## SCHEMATIC REVIEW

RE: QUIZNOS SUB  
Highland Commons Store #11466  
17002 Jefferson Hwy. Ste. C  
Baton Rouge, LA 70817  
(Accepted 9-19-06)

#11466 SCHEMATIC

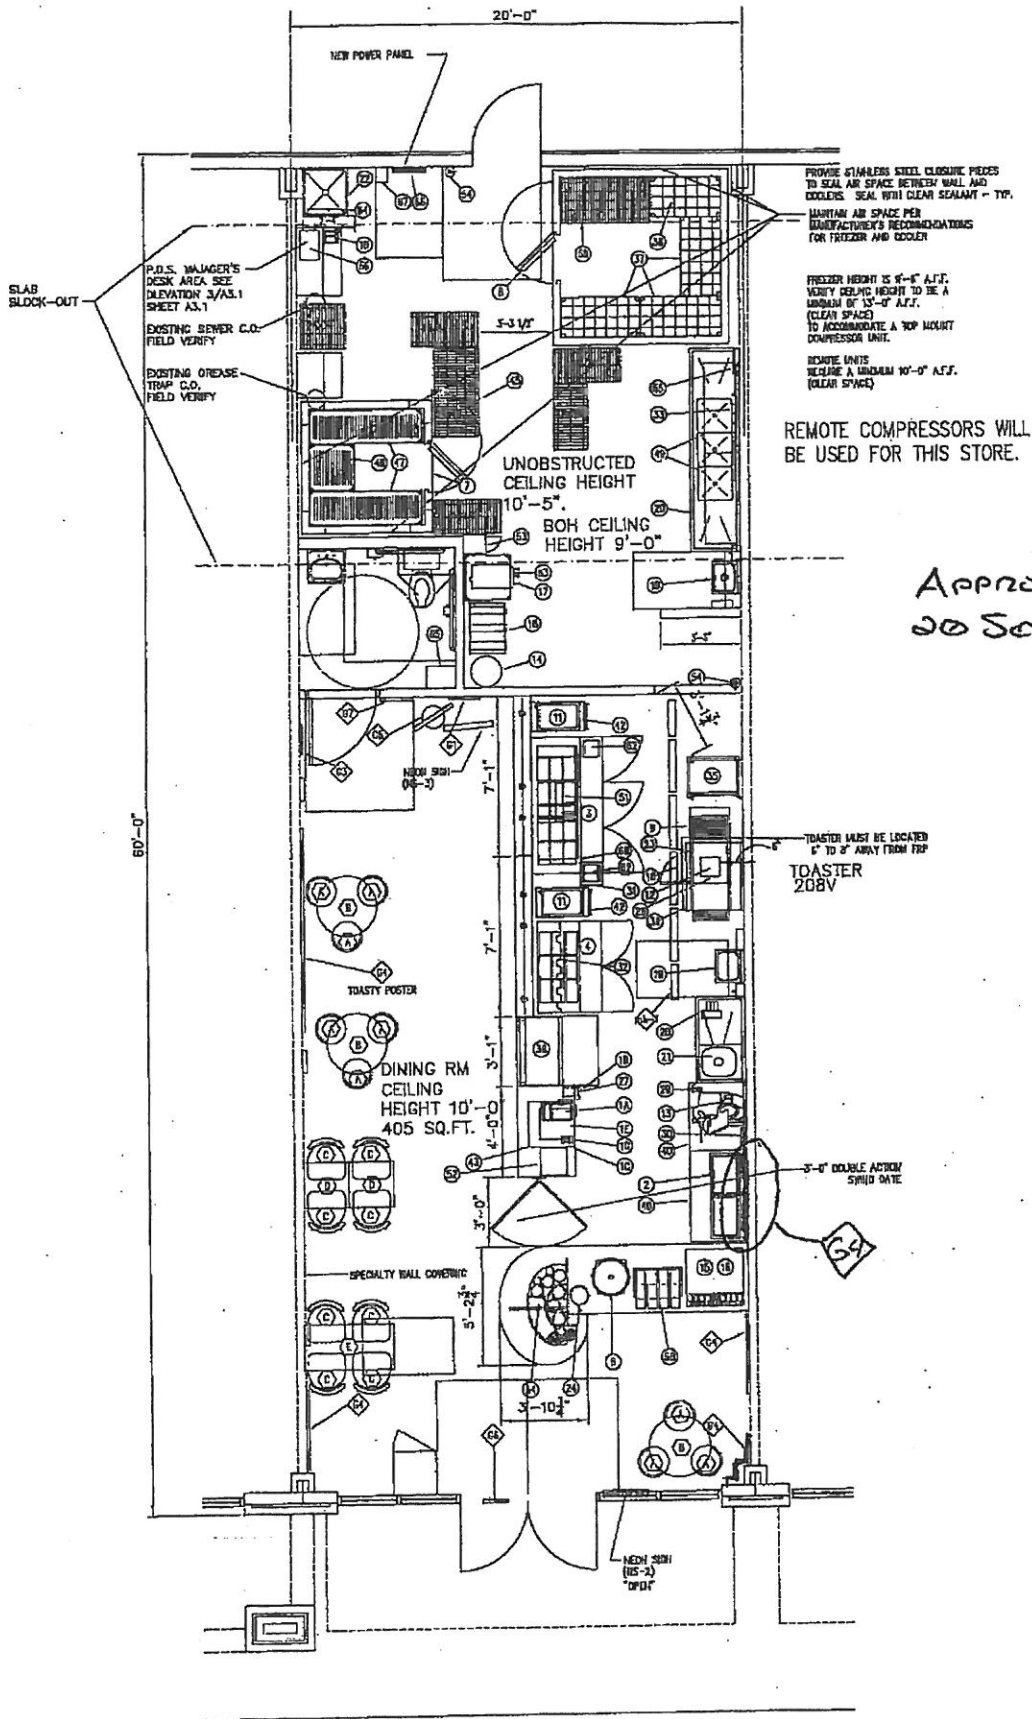
- (a) Five posters come in the art package, display all five (see attached)

- a. This store will use the materials, methods and general information that is found and detailed in the Q2006 Architectural and Construction Manual Version One.
- b. Note: **ANY CHANGES TO THE SCHEMATIC DRAWING AFTER APPROVAL HAS BEEN GIVEN MUST BE RESUBMITTED FOR REVIEW AND APPROVAL.**
- c. All schematics must be drawn per Q2006 Dual Order Design.
- d. Effective immediately, an HVAC form must be completed and submitted with the construction documents, whether the system is new or existing. Construction documents will not be reviewed until it is received.
- e. Quiznos must receive a QVent worksheet, before the construction documents can be reviewed.
- f. All millwork must meet Quiznos' standard specifications.
- g. Remote compressors noted per the schematic. Verify.

- h. A 9'-6" high freezer is standard. Please complete the Kolpak worksheet and return it to our office. Construction documents will not be reviewed until the Kolpak worksheet has been received by the design and construction department.
- i. A 208V toaster is noted. Verify.
- i. Effective immediately – two (2) 20-amp circuits are required for the soup station.
- k. NOTE: The electric panel has been noted NEW on the construction drawings. The GE worksheet must be submitted with the CD's.
- 1. AD is responsible for confirming the sign survey work has been started. The CD's will not be reviewed until the sign quote has been approved by Quiznos' Design & Construction Department.
